**Committee of Experts on the Transport of Dangerous Goods  
and on the Globally Harmonized System of Classification  
and Labelling of Chemicals****Sub-Committee of Experts on the Transport of Dangerous Goods****Fifty-seventh session**

**Recommendations made by the Sub-Committee****at its fifty-fifth and fifty-sixth sessions and pending issues:****review of draft amendments already adopted during the biennium****Consolidated list of draft amendments****Note by the secretariat\***

This document contains a consolidated list of draft amendments adopted by the Sub-Committee of Experts at its fifty-fifth, and fifty-sixth sessions, as follows:

- Part I     Draft amendments to the twenty-first revised edition of the Recommendations on the Transport of Dangerous Goods, Model Regulations (ST/SG/AC.10/1/Rev.21)
- Part II    Draft amendments to the seventh revised edition of the Manual of Tests and Criteria (ST/SG/AC.10/11/Rev.7)

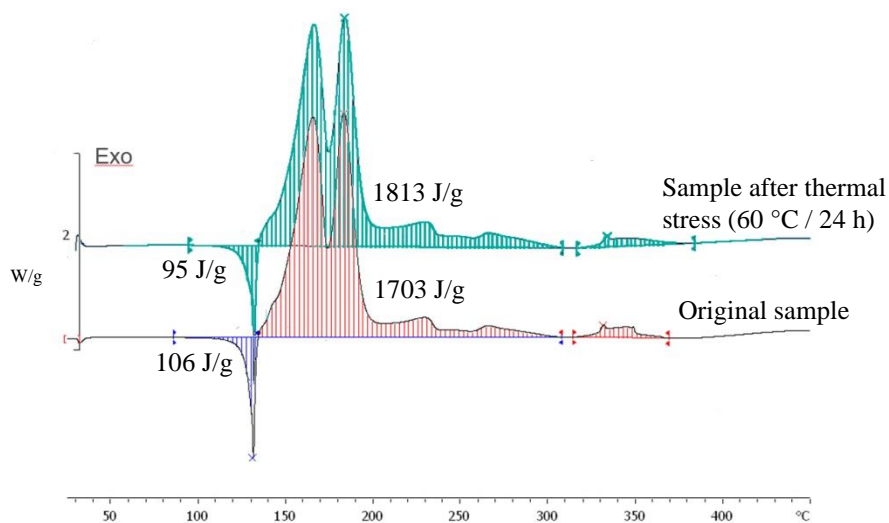
20.3.4.3 For purposes of determining the need for temperature control, a thermal stress test based on DSC measurements may be applied as follows: A DSC is measured as outlined in 20.3.3.3 for the sample as offered for transport. A second sample is taken, and thermal stress is applied by tempering the sample in the closed DSC crucible at a defined constant temperature over a certain period of time. In standard cases, a 24-hour stress time is deemed sufficient. The stressed sample is then cooled to room temperature before being subjected to a DSC measurement at the same heating rate as before. If the decomposition behavior remains unchanged by comparison of the two DSCs in terms of decomposition onset, shape of curve, and energy within a measurement uncertainty of 10 %, the sample is considered stable at the applied stress temperature. For flat peaks with a maximum heat production of 0.2 W/g a deviation of 25 % is tolerable in temperature ranges below 250 °C and 40 % above this limit. If the stress test is passed according to these criteria at 60 °C, then no temperature control is required.

**Figure 20.2: Examples of samples passing the thermal stress test**

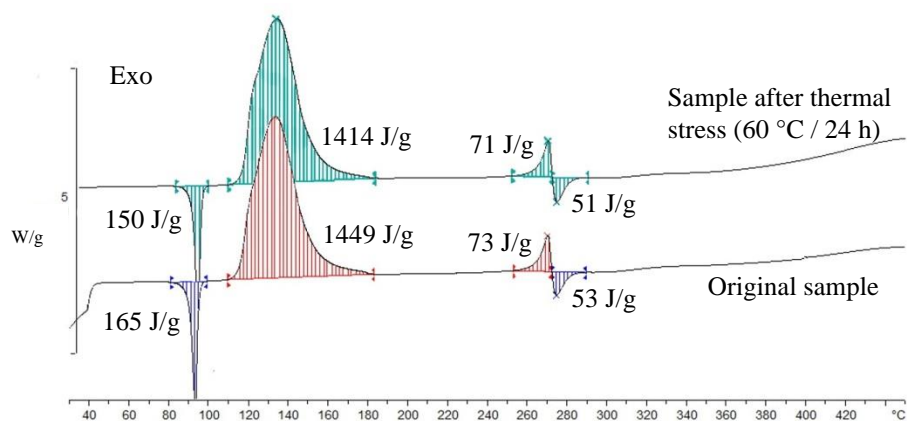
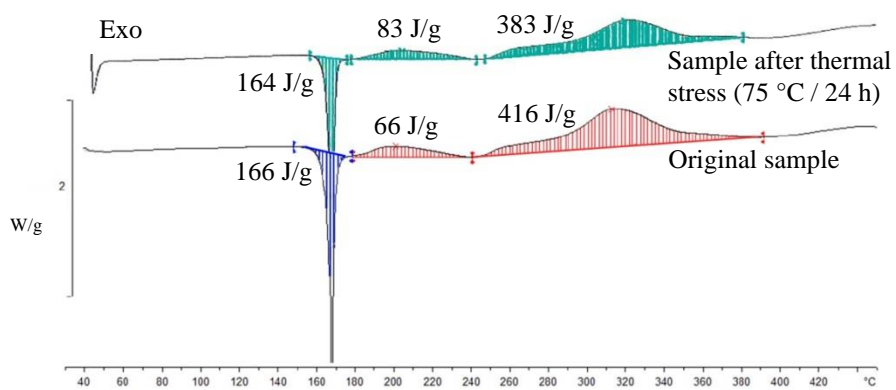
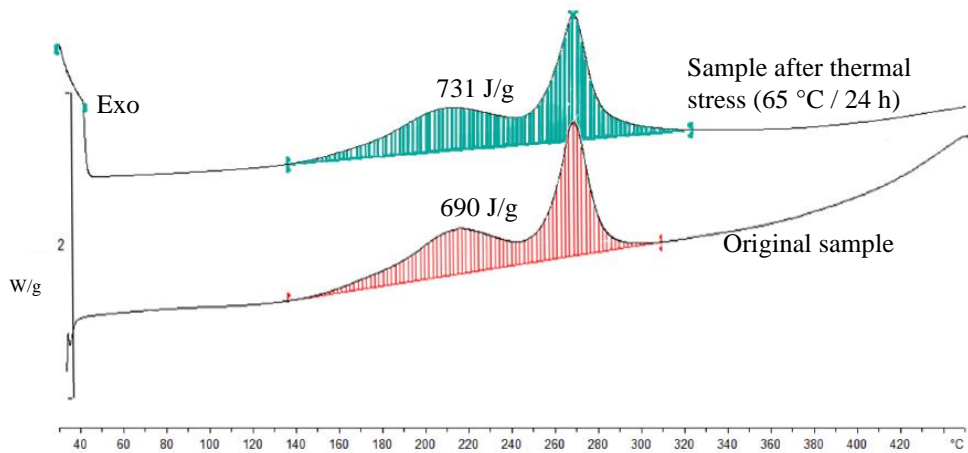
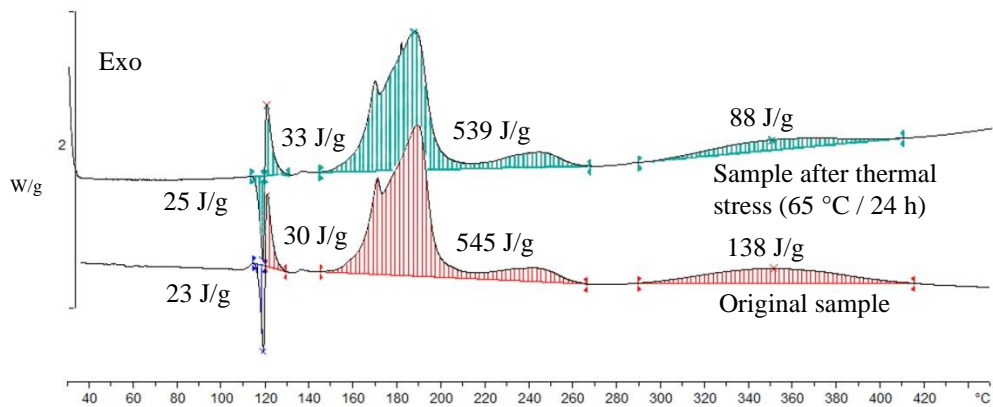
20.3.4.5 Examples for passing the thermal stress test are shown in figure 20.2. Figure 20.3 contains examples of samples failing the stress test. A flow chart for the procedure is given in figure 20.4.
